Access Compliance Report

Public Rights-of-Way

(Curb Ramps)

Intersection ID: 46673	Main Street: GLORY_ST	Cross Street: HUNSLET_CR	Location: SE
ADA ID: A3C0D09B6B19	Ramp Type: Para	Initial Pass/Fail: Fail	Overall Compliance: No
Severity Score: 22.5			
Codes/Mitigation Info/Possible Solution		Field Measurements/Component Compliance

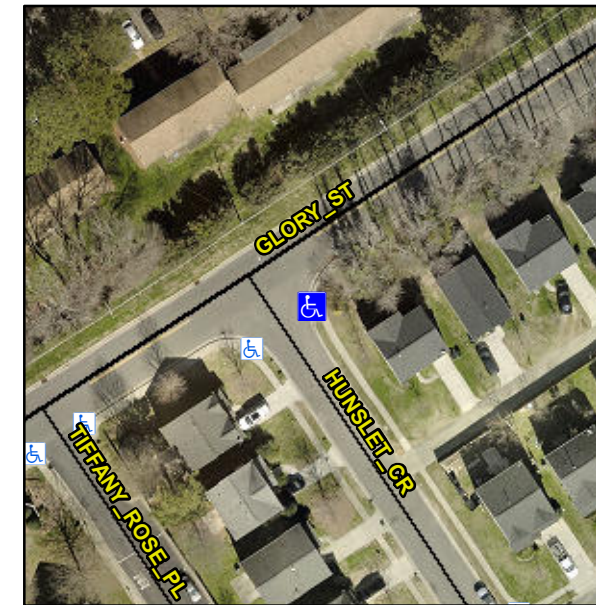
DWS NAILS EXPOSED, RT RP < 5%

R304.5.1, R304.3.2, R304.5.3

Remove & Replace Entire Ramp.
